# Product Safety Recall

## N222383791 Seatbelt Pretensioner Fire

Release Date: April 2023

5443038

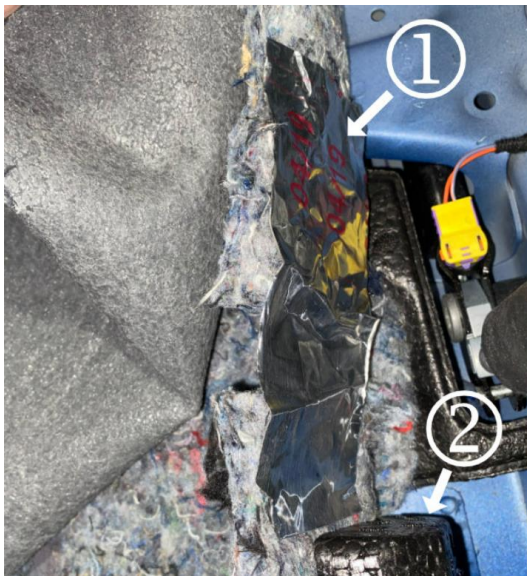
**Important:** If 2.5" width tape is not available and narrower tape must be used, use two layers of the narrower tape overlapped on top of each other to create a 2.5" wide section of material. THIS MUST BE DONE ON THE BENCH BEFORE THE MATERIAL IS INSTALLED ON THE VEHICLE. ENSURE THE LAYERS OF TAPE ARE FULLY ADHERED TO EACH OTHER WITH NO GAPS before it is installed on the vehicle.

26. Prepare two 150 mm (6 in) pieces of 3-M PN 3340 foil tape of an equivalent 2.5" X 4.0 Mil aluminum foil tape meeting UL Spec 181A-P.

6219020

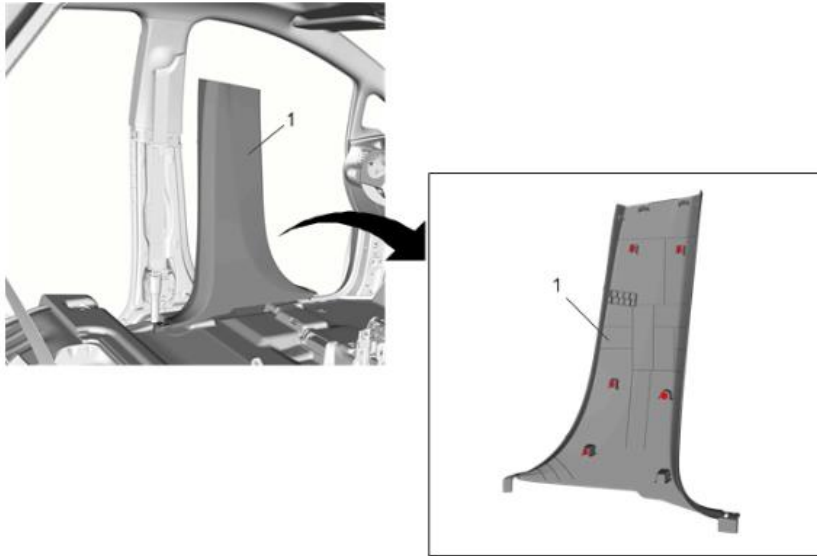
28. Place the second piece of foil tape on top of the insulation lining it up with bottom piece of tape leaving about half the width of the tape hanging off the edge of the insulation.
29. Carefully fold the tape over the edge of the insulation and ensure it fully adheres to the bottom piece of tape as shown above.
